Town of Brunswick, Maine

DRAFT FINDINGS OF FACT REQUEST FOR CERTIFICATE OF APPROPRIATENESS FOR ADDITIONS AND ALTERATIONS VILLAGE REVIEW BOARD

PROJECT NAME: 16 Dunlap Street Enclosed Porch

CASE NUMBER: VRB 25-023

16 Dunlap Street

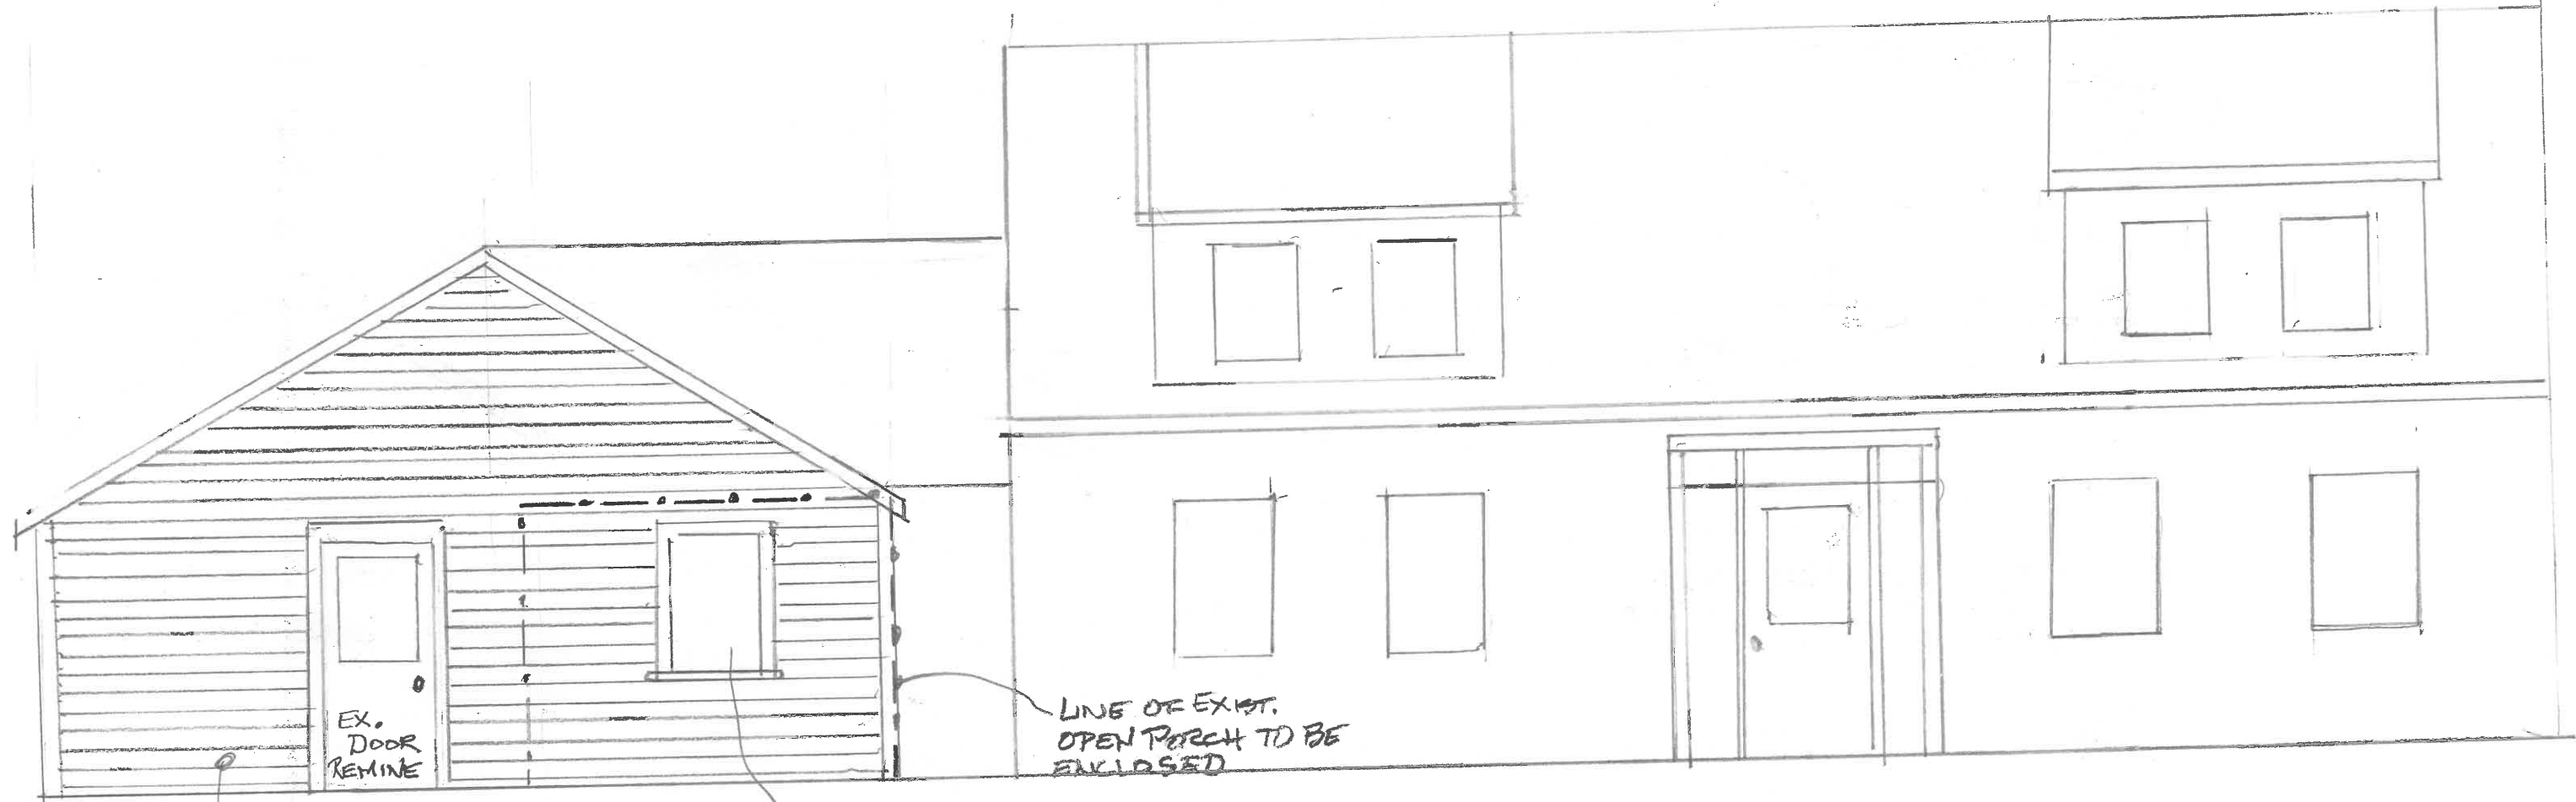
The alterations will remain visually compatible with the streetscape. The proposed project is within the existing footprint of the building and toward the rear of the structure. The addition will include the same white vinyl siding as the remainder of the building which is compatible with neighboring properties.

Vinyl siding is listed as a potentially acceptable substitute siding material within the Village Review Overlay District Design Guidelines as it “evokes the horizontal emphasis of clapboards”. The majority of properties along Dunlap Street are vinyl sided.

The applicant has indicated that the proposed window will be a gridless vinyl window to match the existing windows. Vinyl replacement windows are also common in the contributing structures along Dunlap Street.
